Access Compliance Report

Public Rights-of-Way

(Curb Ramps)

Intersection ID: 47698	Main Street: WATER_OAK_RD	Cross Street: LEES_COURT_ST	Location: NW
ADA ID: 3E6D3FDBF28D	Ramp Type: PerpDiag	Initial Pass/Fail: Fail	Overall Compliance: No
Severity Score: 37.5			
Codes/Mitigation Info/Possible Solution		Field Measurements/Component Compliance

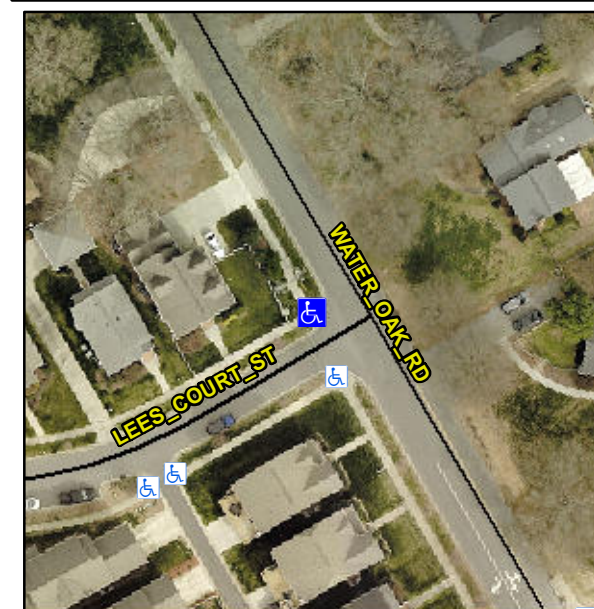
R304.2.2, R304.5.3

Compliance	Description	Data	Compliance	Description	Data
N/A	Ramp Length (in)	108.0	No	Ramp Slope (%)	9.0
Yes	Ramp Width (in)	48.0	No	Ramp XSlope (%)	9.6
N/A	Flare Type LT	N/A	N/A	Flare Type RT	N/A
N/A	Flare Slope LT (%)	N/A	N/A	Flare Slope RT (%)	N/A
N/A	Flare Traversable LT?	N/A	N/A	Flare Traversable RT?	N/A
N/A	Landing Length (in)	N/A	N/A	DWS Provided?	N/A
N/A	Landing Width (in)	N/A	N/A	DWS Contrast?	N/A
N/A	Landing Slope (%)	N/A	N/A	DWS Length (in)	N/A
N/A	Landing X Slope (%)	N/A	N/A	DWS Full Width?	N/A
N/A	Landing Curb? (Y/N)	N/A	N/A	DWS Offset (in)	N/A
N/A	Shared Landing?	N/A			
N/A	Gutter Ponding?	N/A	N/A	Gutter Slope (%)	N/A
N/A	Gutter Lip Ht (in)	N/A	N/A	Gutter X Slope (%)	N/A
N/A	Painted X Walk1?	No	N/A	Painted X Walk2?	No
	X Walk 1 Direction	To SE		X Walk 2 Direction	To E
N/A	X Walk 1 Width (in)	N/A	N/A	X Walk 2 Width (in)	N/A
	X Walk 1 Slope (%)	3.2		X Walk 2 Slope (%)	4.0
	X Walk 1 X Slope (%)	6.3		X Walk 2 X Slope (%)	4.1

Remove & Replace Curb Ramp With Two New Directional Ramps or Equivalent.
